World Forum for Harmonization of Vehicle Regulations

Proposal for Supplement 16 to the 02 series of amendments to UN Regulation No. 117 (Tyre rolling resistance, rolling noise and wet grip)

Submitted by the Working Party on Noise and Tyres*

Figure 1
Nomenclature explanation related to grip index of the tyre

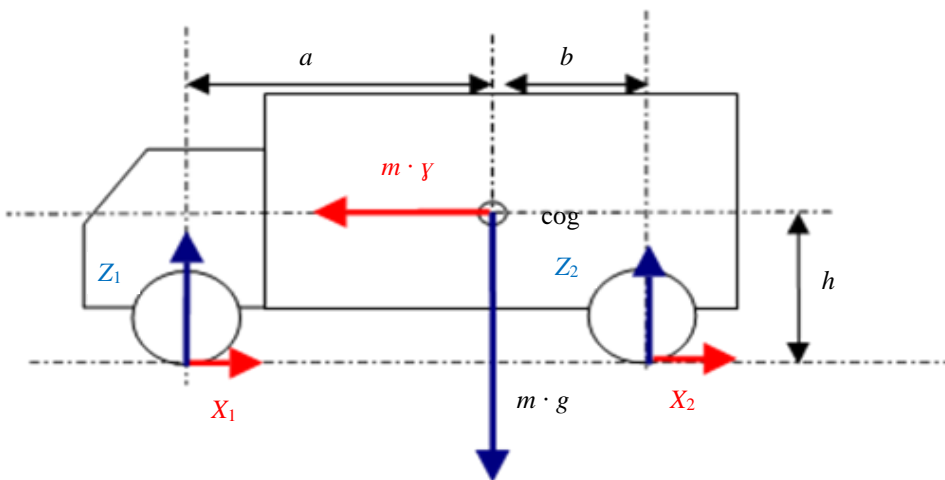
Paragraph 2.2.2.7.5., amend to read:

"2.2.2.7.5. Calculation of the relative wet grip index of the tyre

The wet grip index represents the relative performance of the candidate tyre compared to the reference tyre. The way to obtain it depends on the test configuration as defined in paragraph 2.2.2.2. of this Annex. The wet grip index G of the tyre is calculated as reported into Table 7:

Configuration C1: candidate tyres on both axles	$G = f \cdot \frac{BFC(T)}{BFC(R)}$
Configuration C2: candidate tyres on front axle and reference tyres on rear axle	$G = f \cdot \frac{BFC(T) \cdot [a + b + h \cdot BFC(R)] - a \cdot BFC(R)}{BFC(R) \cdot [b + h \cdot BFC(T)]}$
Configuration C3: reference tyres on front axle and candidate tyres on rear axle	$G = f \cdot \frac{BFC(T) \cdot [-a - b + h \cdot BFC(R)] + b \cdot BFC(R)}{BFC(R) \cdot [-a + h \cdot BFC(T)]}$

Where (see also Figure 1):

- f*: correction factor depending on used SRTT
 - cog*: centre of gravity of the loaded vehicle
 - m*: mass (in kilograms) of the loaded vehicle
 - a*: horizontal distance between front axle and centre of gravity of the loaded vehicle (m)

- b*: horizontal distance between rear axle and centre of gravity of the loaded vehicle
 - h*: vertical distance between ground level and centre of gravity of the loaded vehicle (m).

- N.B.* When *h* is not precisely known, these worst case values shall apply: 1.2 for configuration C2, and 1.5 for configuration C3
- γ*: loaded vehicle acceleration [m·s⁻²]

Figure 1

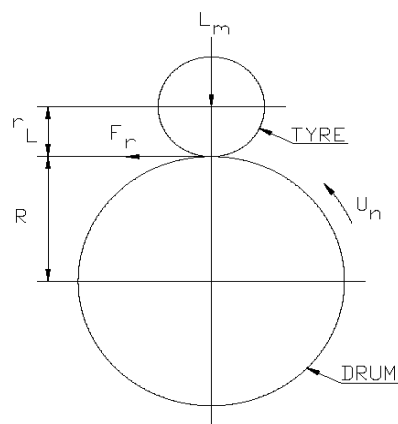
Paragraph 4.5., amend to read:

"4.5. Measurement and recording

The following shall be measured and recorded (see Figure 1):

- (a) Test speed U_n ;
- (b) Load on the tyre normal to the drum surface L_m ;
- (c) The initial test inflation pressure as defined in paragraph 3.3. above;
- (d) The coefficient of rolling resistance measured C_r , and its corrected value C_{rc} , at 25 °C and for a drum diameter of 2 m;
- (e) The distance from the tyre axis to the drum outer surface under steady state r_L ;
- (f) Ambient temperature t_{amb} ;
- (g) Test drum radius R ;
- (h) Test method chosen;
- (i) Test rim (size and material);
- (j) Tyre size, manufacturer, type, identity number (if one exists), speed category symbol, load index, DOT number (Department of Transportation).

All the mechanical quantities (forces, torques) will be orientated in accordance with the axis systems specified in ISO 8855:2011.
